**CITY OF
PARRAMATTA**

Submission

To the Department of Planning, Industry
and Environment

In response to the public exhibition
of the 2020 revised draft master
plan for the Carter Street
Precinct

Figure 4 – Specific sites that are able to achieve additional height and floor space – proposed HOB and FSR maps

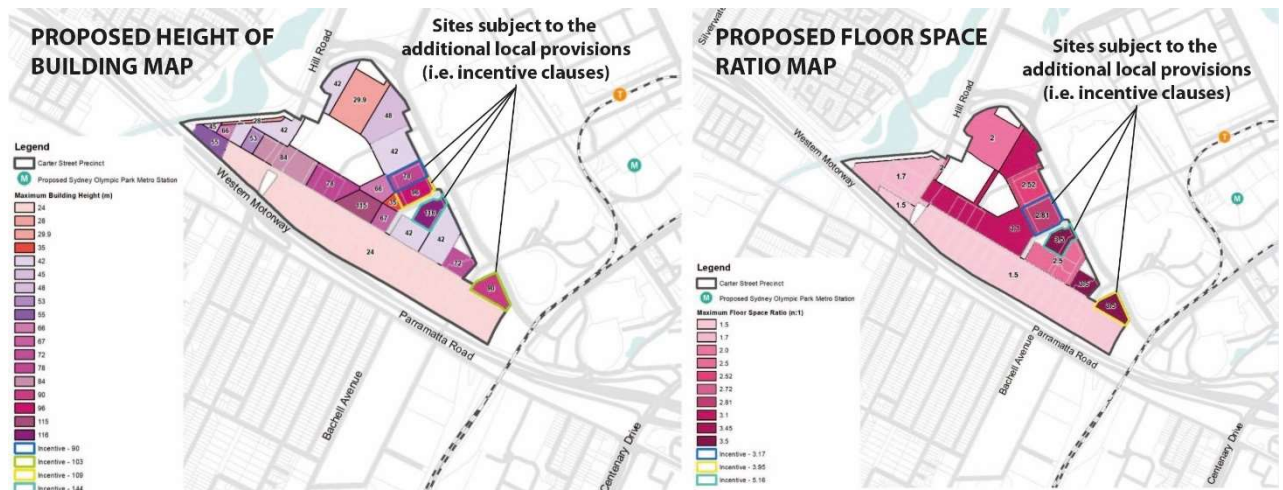
Council raises concerns relating to the proposed additional local provisions as the applicable sites identified have active development applications (DAs) currently under assessment. It is unclear whether these incentives are applicable to the whole of each identified site, or if they are applicable only to the portion that achieves an uplift by reducing car parking as per the proposed additional local provisions. It is acknowledged that under the CSMP's *Explanation of Intended Effects* it is stated that, "any development uplift will be subject to a reduction in car parking rates", however, it is not made clear how this ought to be implemented.

It is Council's understanding that the existing car parking rates under the Carter Street Development Control Plan 2016 (DCP) would be applicable to the base floor space ratio for the specific sites identified under the CSMP since these rates are intended for a Precinct of 5,500 dwellings. However, if these sites were to seek the additional uplift as part of the proposed incentive clauses, then the reduced parking rates as per the CSMP would be applied to this uplift. Whilst this is Council's interpretation of the implementation of the incentive clauses, it is not made clear in the exhibition package of how they ought to be practically implemented. The exhibited CSMP does not include any draft clauses of the proposed additional local provisions that would provide clarity around how these controls would be applied.

Council recommends that the DPIE provide draft clauses to Council prior to any finalisation of the CSMP and that Council be involved in the drafting process, and that further clarification be made regarding their application.

Figure 5 – Minimum active street frontages

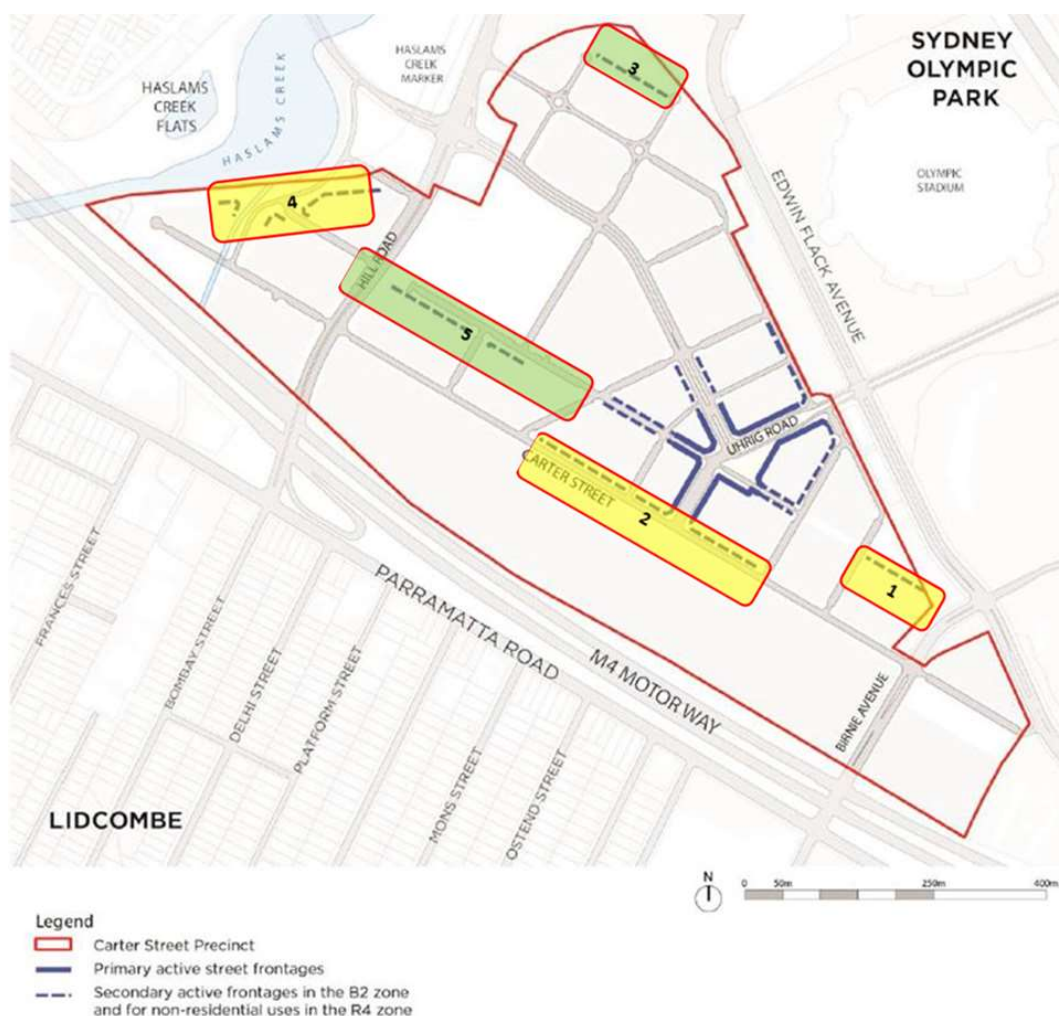
Some of the active edges show in the active frontage map have already been delivered and are unlikely to change. Furthermore, not all identified active street frontages under the draft *Development Framework* has a street front (e.g. Meriton Phase 1). This needs to be amended to reflect the existing and approved built form. This is shown in **Figure 5** below.

1. Area 1 highlighted has already been built and presents a residential edge to the pocket park. This is unlikely to change.
2. Single sided active uses near a high pressure pipeline and industrial uses south of Carter Street setback from the street, is not supported.

4. Some sites do not have public access. This is not supported unless easy and generous public access is guaranteed with views to Haslams Creek. Given a recent court resolution limiting access at the western end of the precinct, this active frontage is supported only if clear, uninterrupted/continuous and generous public access is available 24/7 along the foreshore.

5. The proposed active frontage along the future park is supported subject to size restrictions, fine grain and adaptable uses – not a high street of shops.

Figure 6 – Missing “indicative future pedestrian and cycle link” under the Structure Plan of the *Development Framework*

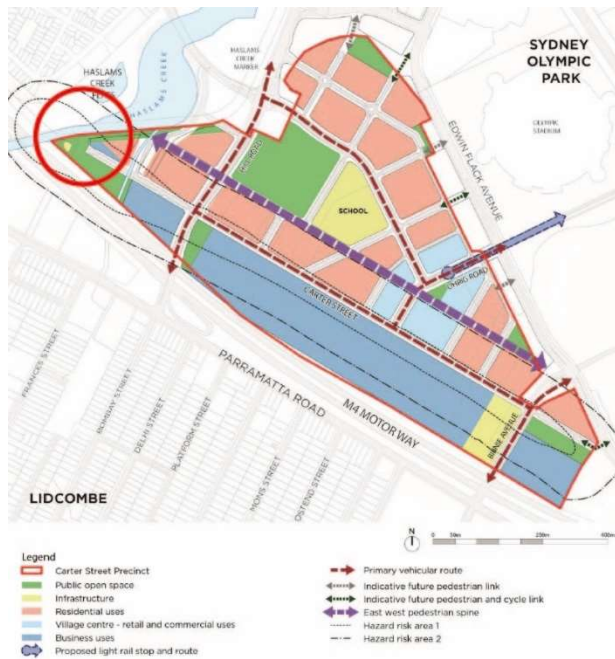
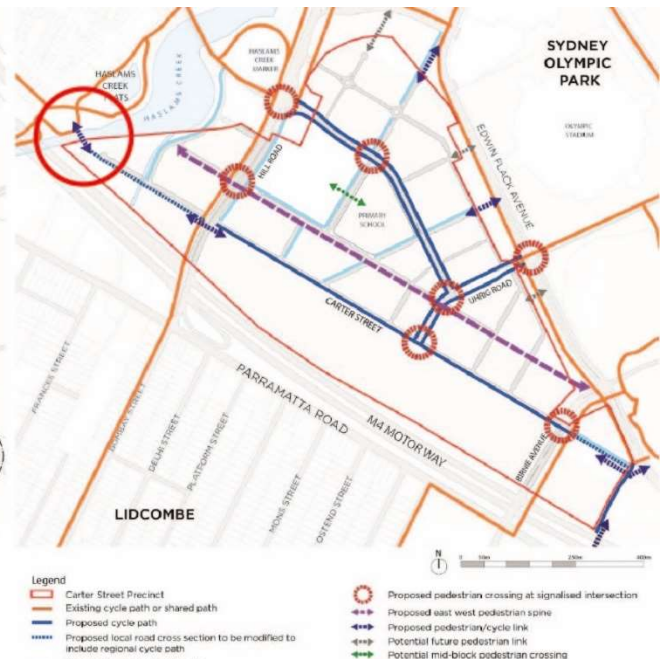
1. The structure plan (Figure 3 under the *Development Framework*, p9) is missing the "indicative future pedestrian and cycle link" at Hill Road, over the M4 and Haslams Creek. This is inconsistent with Figure 19 under the *Development Framework* and needs to be rectified. Refer to **Figure 6** below for a side-by-side image which highlights the missing "indicative future pedestrian and cycle link".

Figure 7 – City of Parramatta Council’s preferred cross section in response to Figure 15 under the *Development Framework*

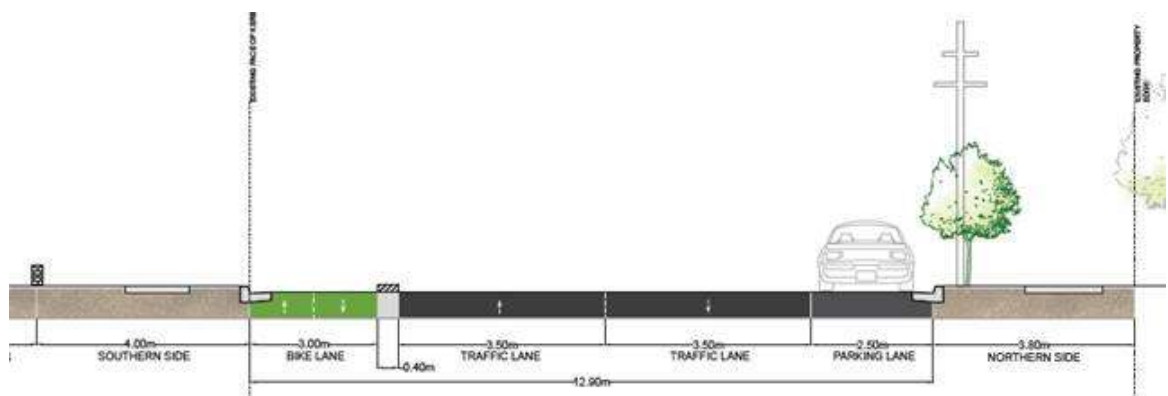
- Figure 15 of the *Development Framework* (p34) indicates that parking will be on the southern side of Carter Street. Council requests that parking be moved to the northern side as there will be issues for large left turning vehicles eastbound and southbound.
- Council agrees that the lane and parking widths under Figure 15 of the *Development Framework* (p34) can be supported. However, drainage is preferred to not be moved and therefore the light poles are requested to be between the bicycle path and footpath as per Council’s cross section (see **Figure 7** below).

Figure 10 – Proposed open space to be delivered under the State planning agreement

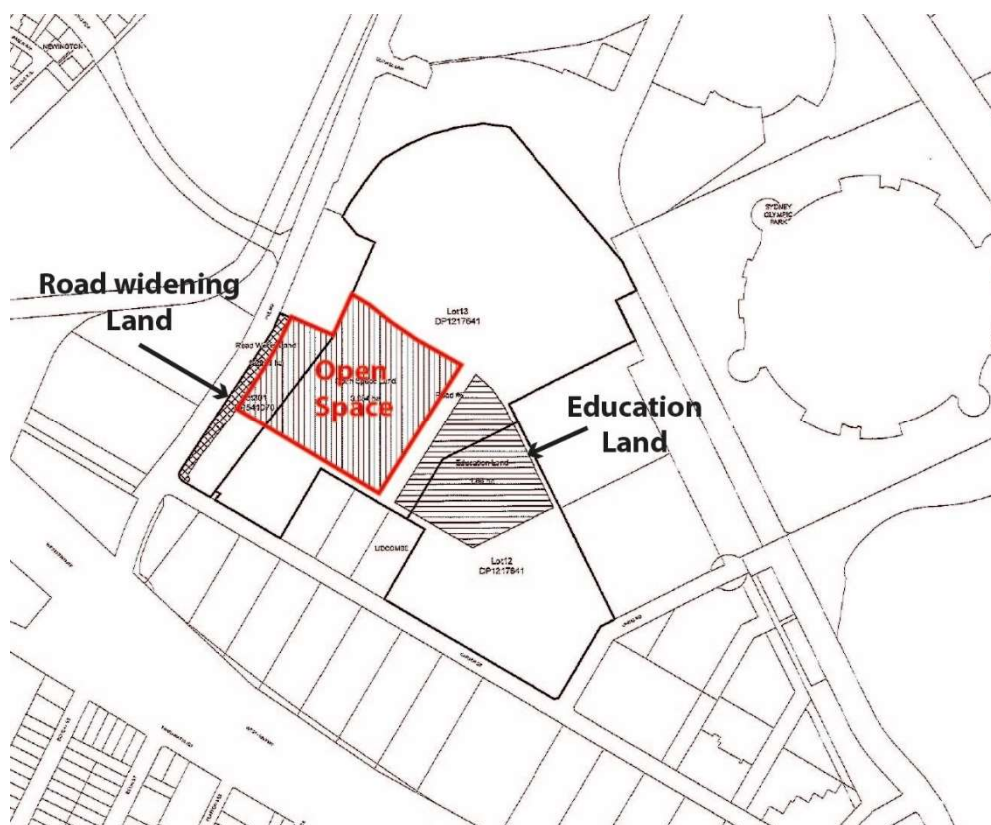
Council is supportive of the transfer of the open space for public benefit under the State planning agreement. However, concerns are raised in relation to the transfer mechanism and its potential transfer to Council. Under the State planning agreement, this transfer of land is to be delivered from YMCI to the Minister or Minister's nominee without explicit mention of Council as the recipient. Further clarification of this matter is required to ensure that Council is secured as the recipient. **Appendix C** of this submission provides draft legal wording that can be included in the State planning agreement to ensure that Council is nominated as the recipient of the Open Space Land.

Figure 2 – Western Corner of the Precinct (2 Hill Road) developable area and risk buffer zones

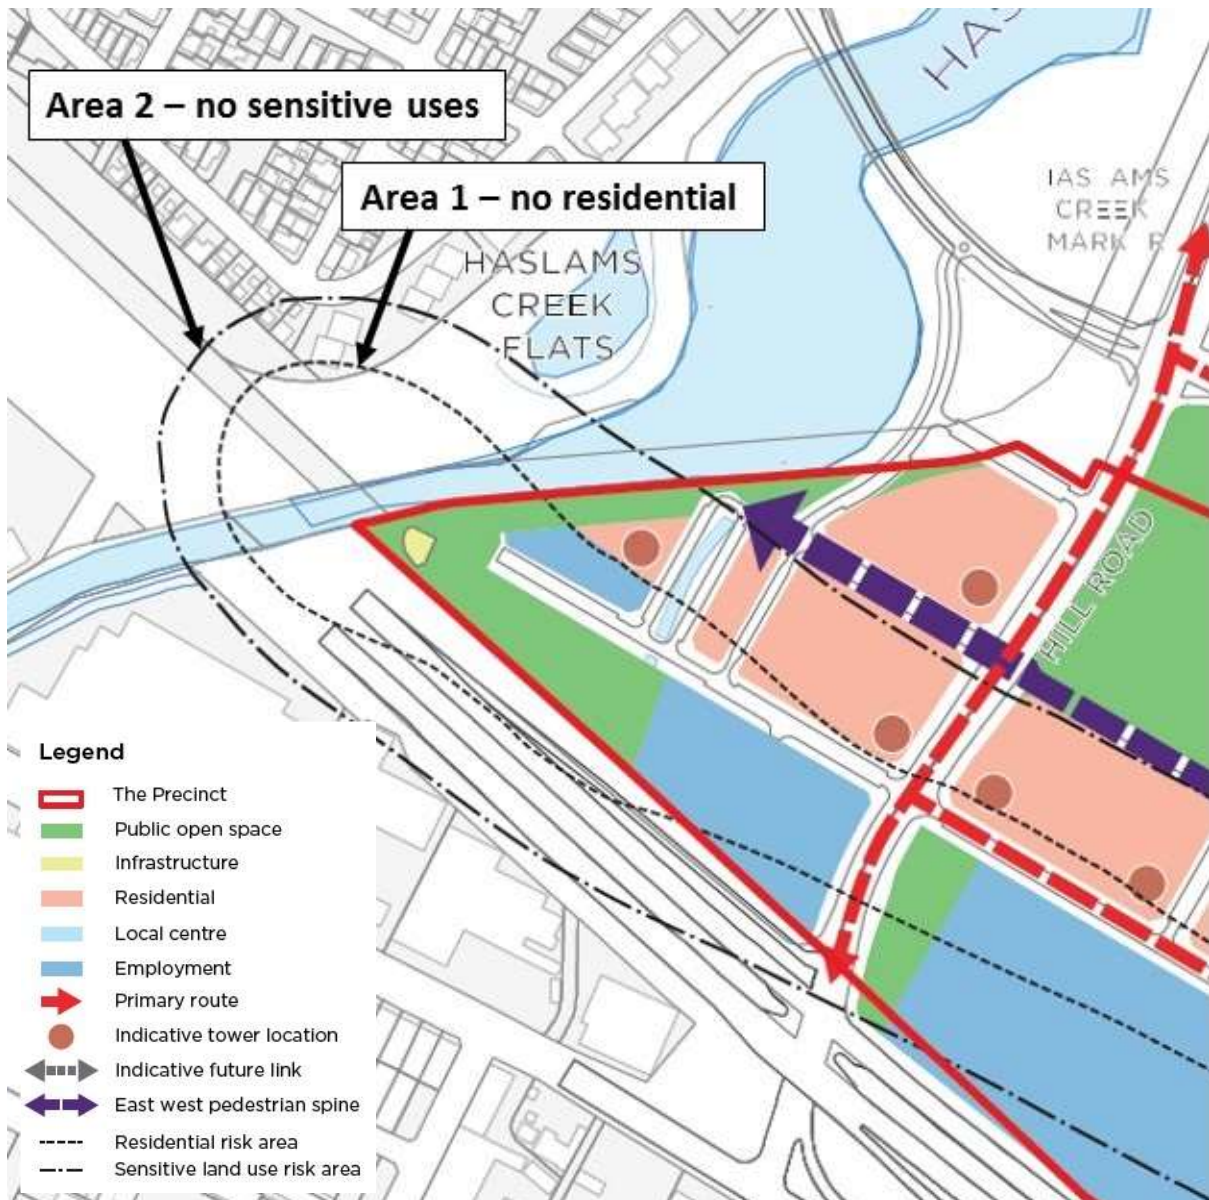
16. However, Council has significant concerns over the site (2 Hill Road) at the western corner of the precinct bound by the M4, Haslams Creek and Hill Road. This site currently zoned R4 High Density Residential and is proposed under the CSMP to be retained as R4 despite the Land Use and Safety Study (supporting the revised CSMP) identifying a significant portion of the site as being within the high risk buffer zone which is identified as not being suitable for sensitive land uses (e.g. childcare centres) and residential development due to the adverse risk profile. The northern portion of the site can accommodate residential development, but not sensitive land uses (see **Figure 2** below).

17. Given the additional information provided as part of the draft CSMP through the Land Use and Safety Study, it is recommended that the LEP be amended accordingly to reflect the true development outcome envisaged for the site i.e. part employment/business zone, part high density residential as opposed to retaining the whole site as R4 (with an additional permitted use to allow business/employment uses). It is acknowledged the draft DCP attempts to manage this issue by identifying the southern portion of the site for employment uses while a residential tower is located

Figure 6 – Indicative Light Rail stop and proposed increase to the Village Plaza

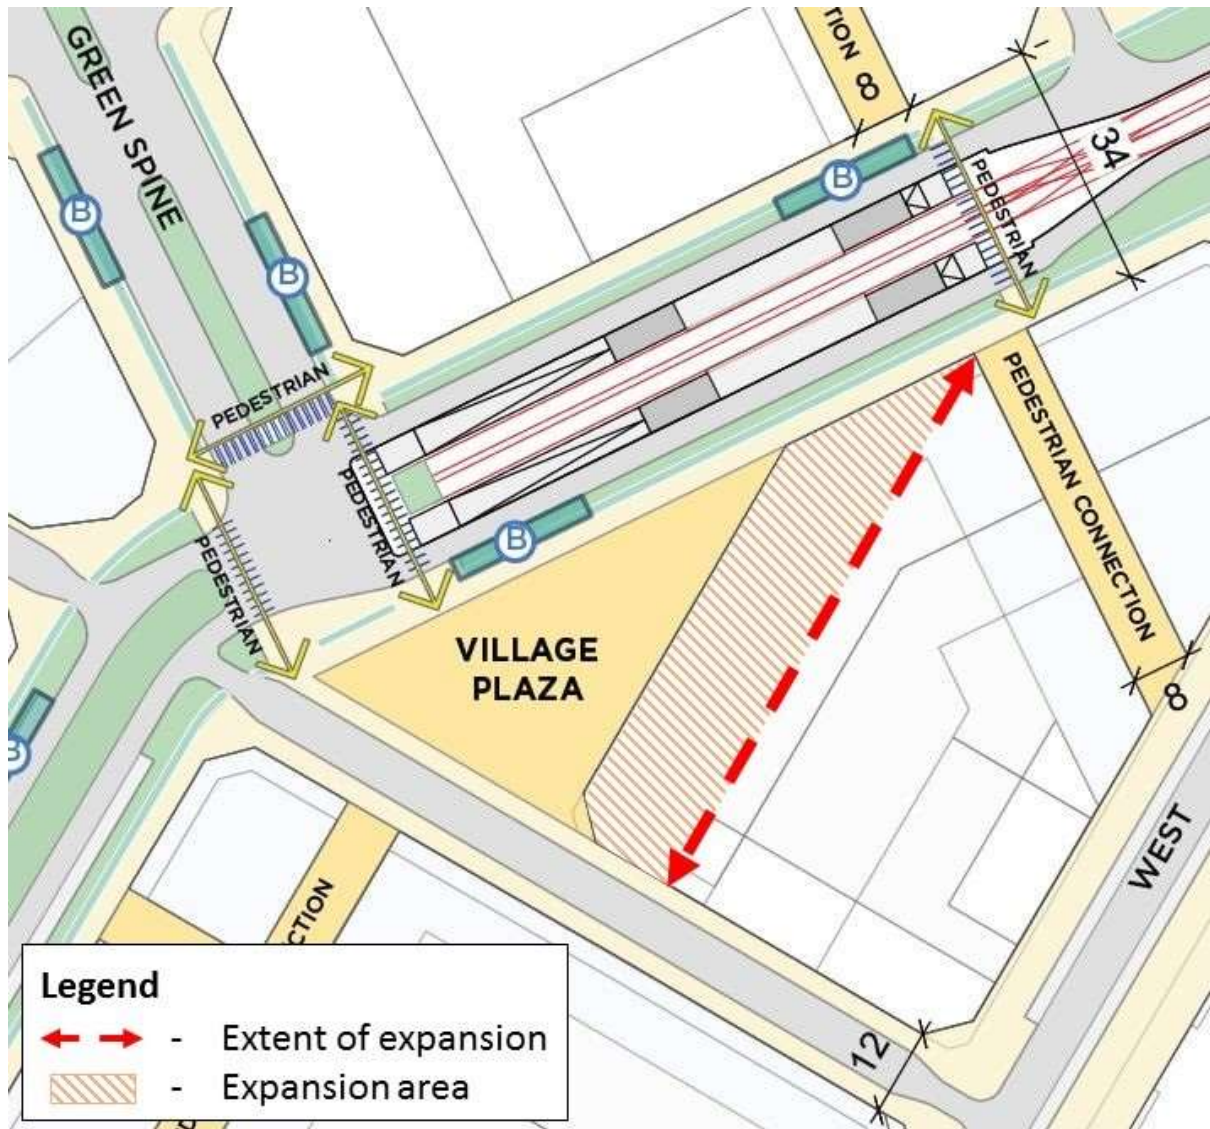
- D7.** Section 6.13 of the UDR suggests that the town centre / village plaza terminus section of Stage 2 Light Rail will be catenary free operated. Council officers support this suggestion, although this does not seem to be reflected in the cross sections in the master plan which show overhead wiring. This needs to be clarified.
- D8.** Council officers generally support the location of the public open space (Village Plaza) to be adjacent to the indicative light rail stop at Uhrig Road. That said, Council officers consider an increased area of open space that allows the light rail stop to better align with the RE1 zone would improve the urban design outcome. It is recommended that the open space zone be extended as per the red dashed line in Figure 6 (identified in the DCP as public open space but not zoned

RE1) below labelled 'Village Plaza' to address this including implications on height and FSR for the development block to the east.

Figure 1 - Proposed ground level built form setbacks

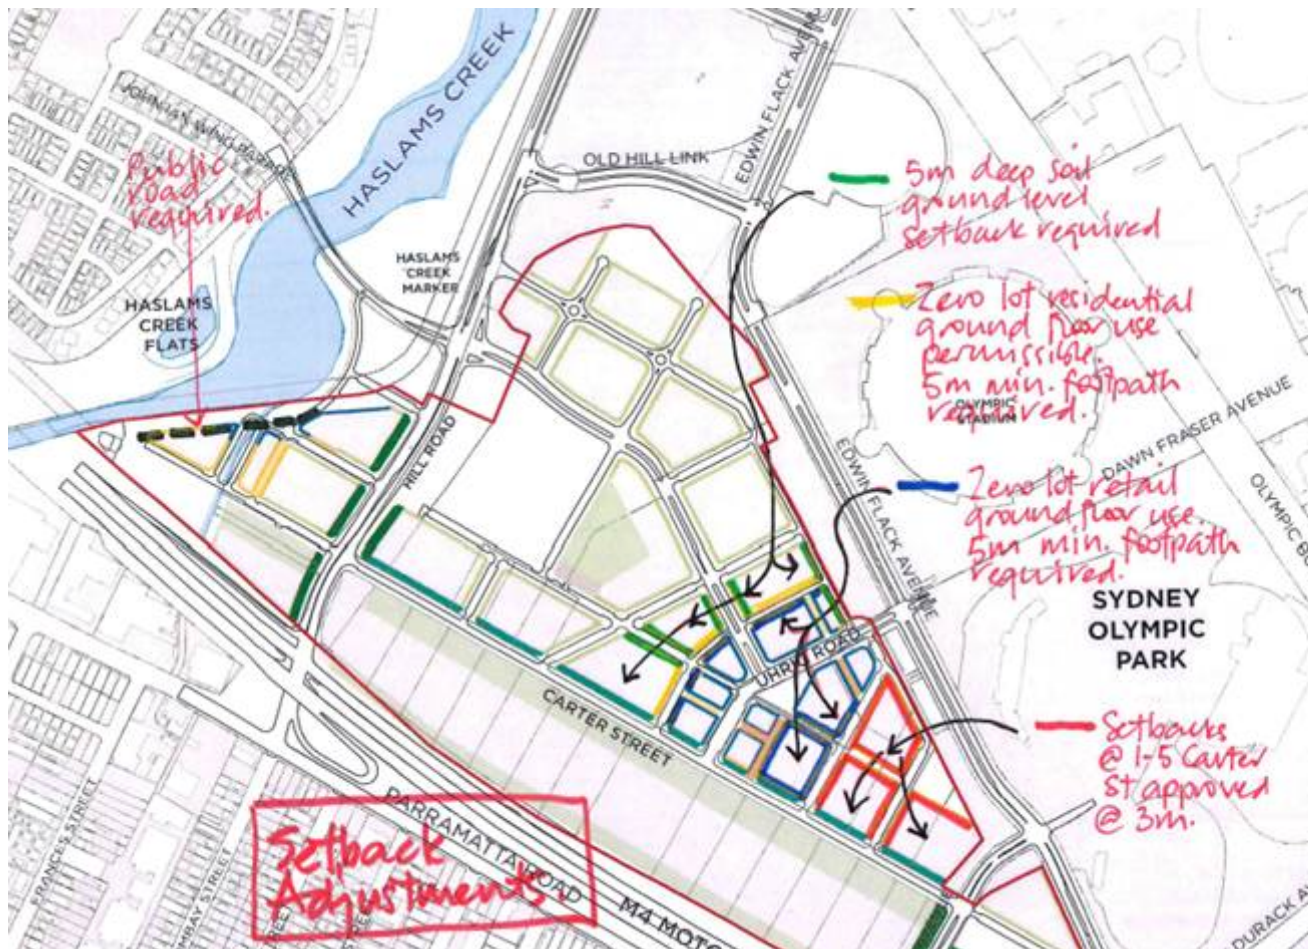
13. Built Form Ground Level Setbacks (refer UDR, Figure 50) – Please note amendments and corrections required as shown on the mark-up drawing below based on the following strategies:
- 5m setback required for residential ground floor use
 - 0m setbacks typically permissible for retail/commercial ground floor use only.
- For these interfaces a 5m minimum width footpath is required to

- c. Approved built form ground level setbacks at 1-5 Carter Street are 3m. These were approved in accordance with the requirements of the existing Carter Street DCP.

Recommendation – Refinement of master plan documentation to reflect the above built form ground level setback requirements is required.

Figure 2 – Figure 19 of the UDR showing two roads that do not currently exist

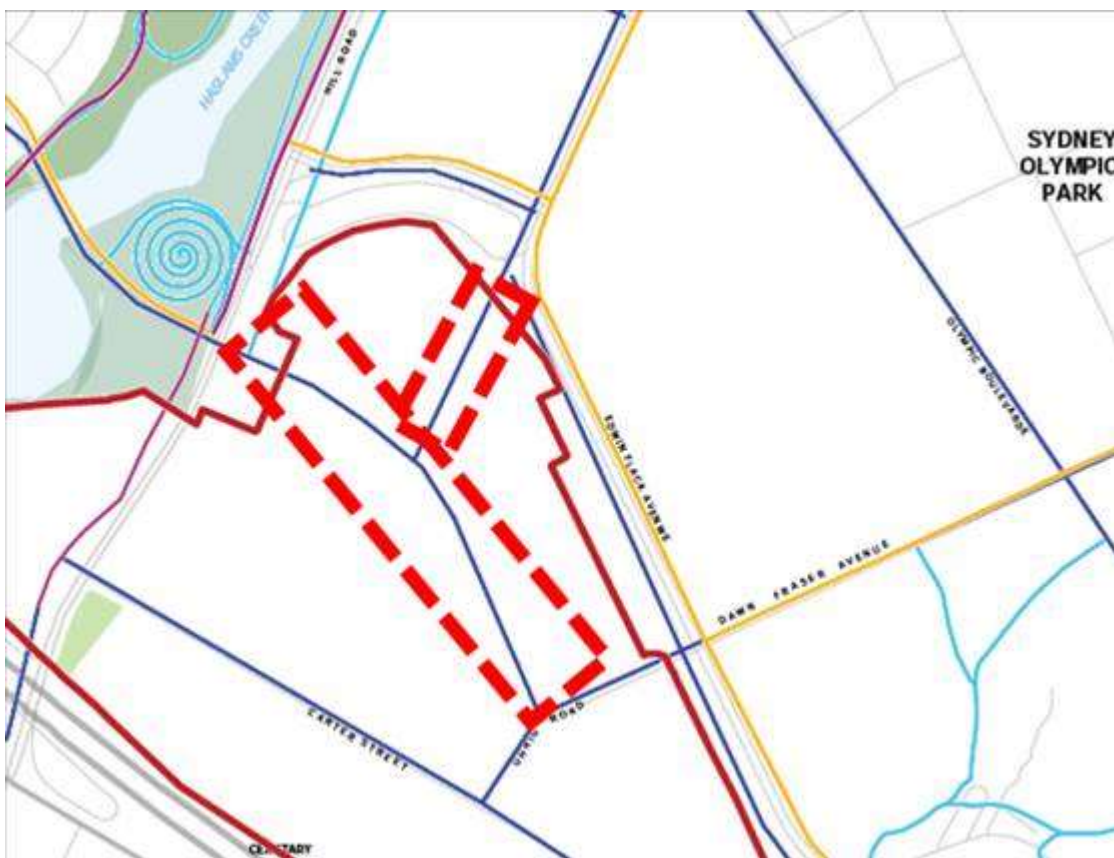
16. Section 4.9 of the UDR, Figure 19 shows two roads that do not currently exist (highlighted in **Figure 2**). Furthermore, Figure 19 shows “Employment area / activity centre” as an item on the legend but none is shown on the map.

Recommendation - This needs to be updated to reflect the commercial zone south of Carter Street.
